PC111 2627a) LHI – design review

Attached: **Designs - October 2026 - 30CPX04668_Design_C01 Rev 1.1**

Project
LOCAL HIGHWAY IMPROVEMENTS 25-26
ORCHARD ROAD, MELBOURN
TRAFFIC CALMING

VIEWPORT 2: PROPOSED GIVEWAY FEATURE -
SCALE: 1:250 @ A3

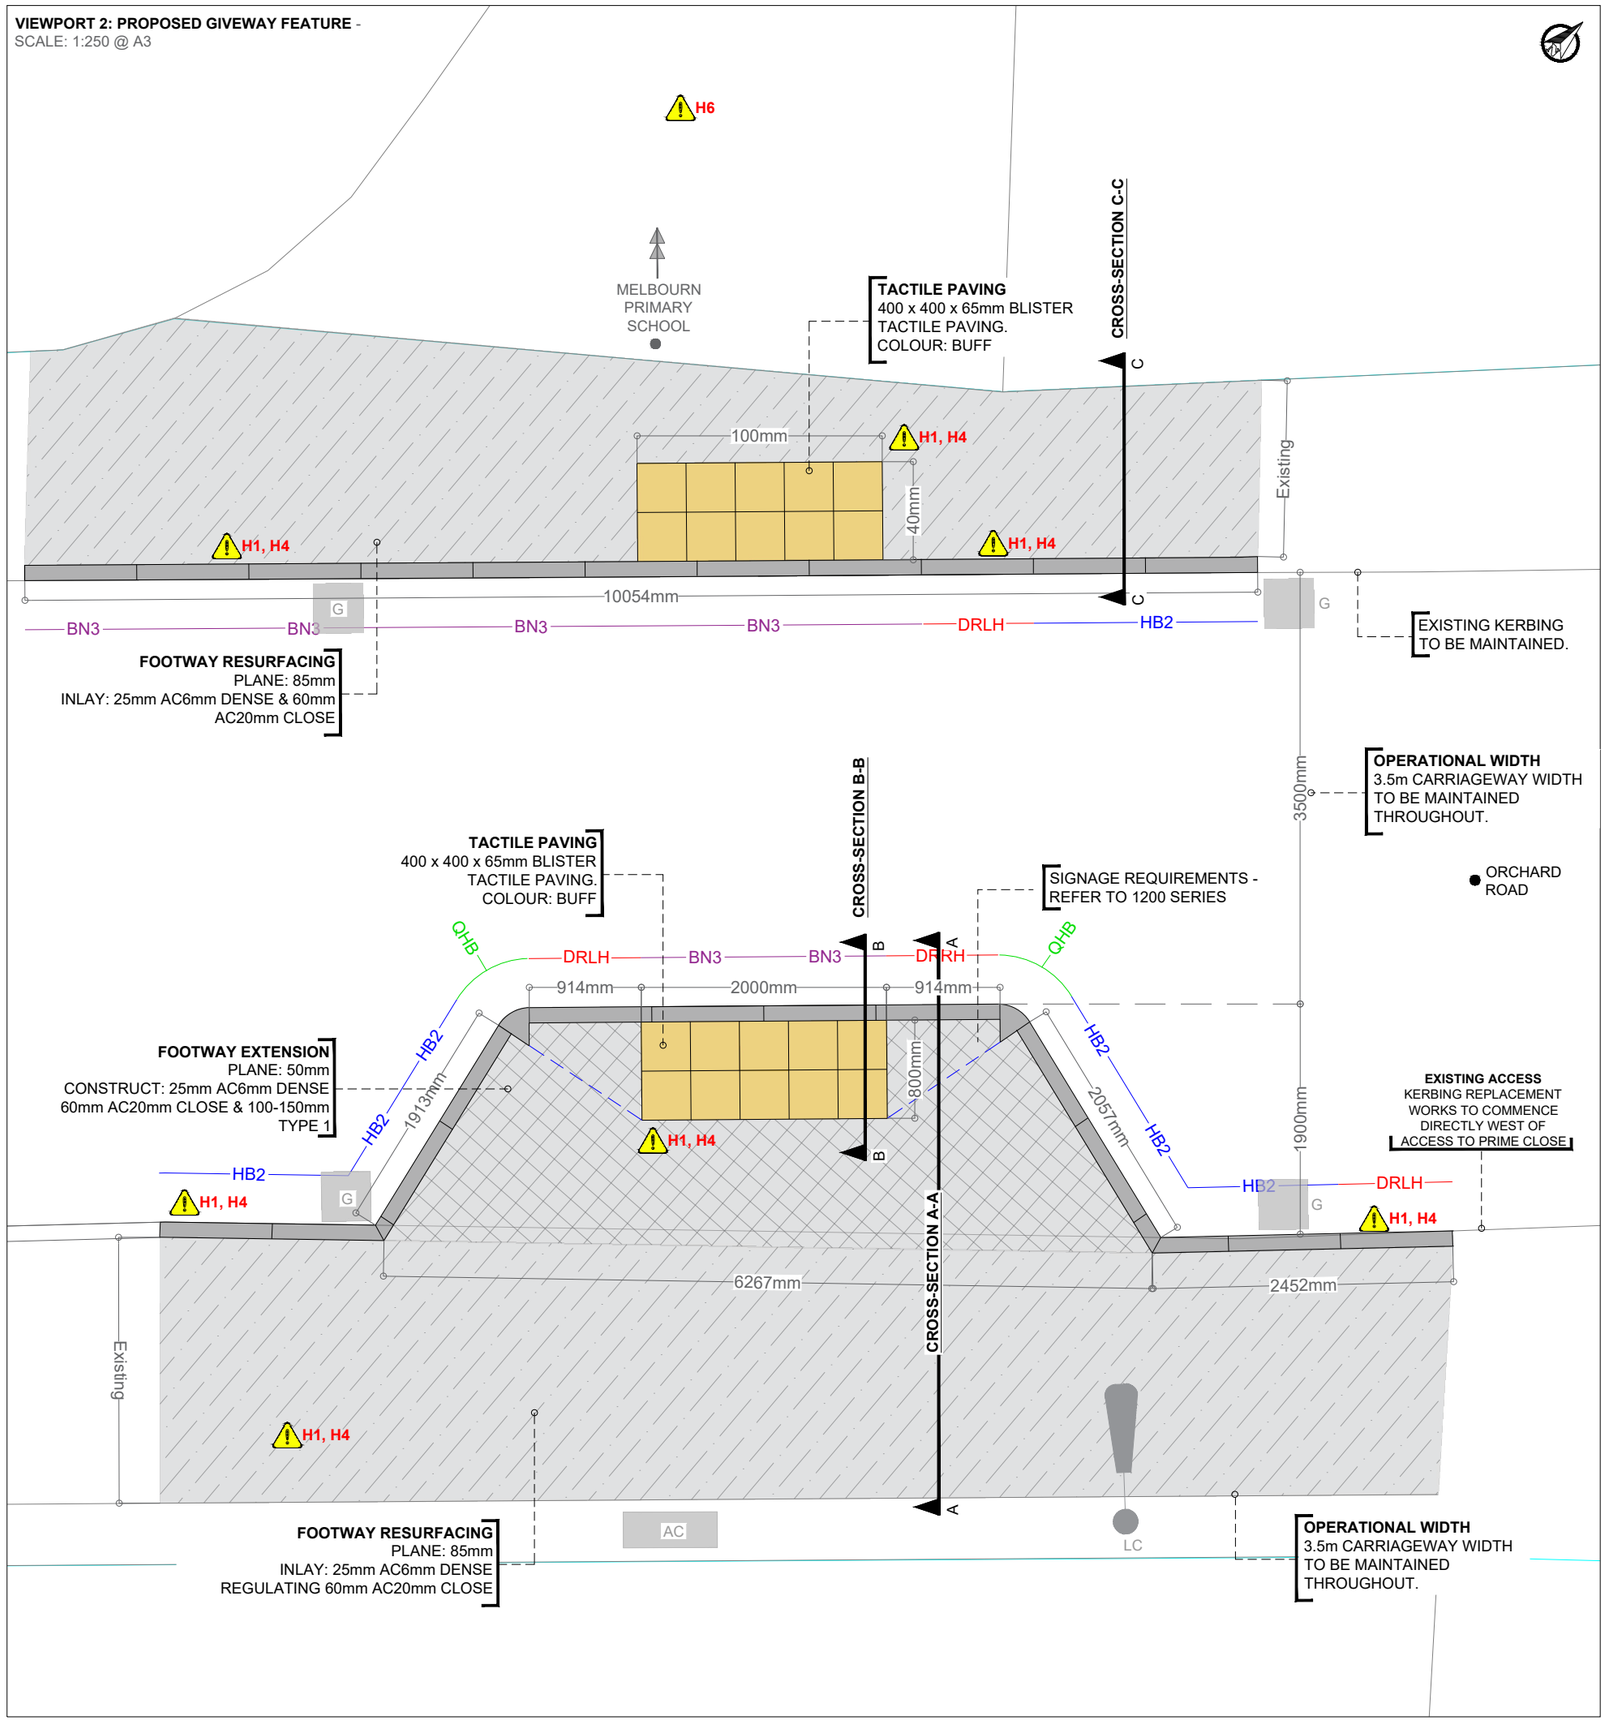
- Cllr1: They appear to have put the pinch point the wrong way round. Part of the idea is the provide more space on the school entrance side, as per the one on Mortlock Street.
- Cllr 2: The narrowing was to be on the school side to allow greater pavement space coupled with the slowing down of traffic.

- Cllr 1: A major benefit of the proposal would be the increased space on the school side of the road.
  We should consult the school to see if:
  - Emergency access is required through the gates, given the proximity of the car park through which vehicles can and do enter the school site
  - The bins could be moved to the car park.

If the design proposal remains on the opposite side then I will withdraw my support and vote against it.

I see that the Chicane is now going to be put on the other side of the road, right outside our house, this will increase parents and therefore the noise level will increase too.
  It is very disappointing that the Parish Council will not consider residents and will not see that both schemes are not needed.

Location in relation to the lighting column:

- *Our proposals are adjacent directly to the lighting column, which improve illumination for awaiting pedestrians.*
  - *Our proposal is also slightly more cost effective than the suggested 'eastbound' location. For the illuminated sign installation, the design requires access to electrical feeds from the lighting columns - which in our case can be directed straight into the adjacent lighting column. The feeder pillar may also be placed in the grass verge too, as opposed to compromising footway width, which would be the case with an 'eastbound' set up.*

Access to Melbourn Primary School:

- *There is an existing access to the Primary School aided by double gates. This should be maintained for both waste removals (access to the stored bins) and also emergency access to the school.*
  - *Additionally, the build out requires full height kerbing. If we were to provide some access to the gates also, dropped kerbs would be required here. This would pose risk to drainage and constructability challenges.*
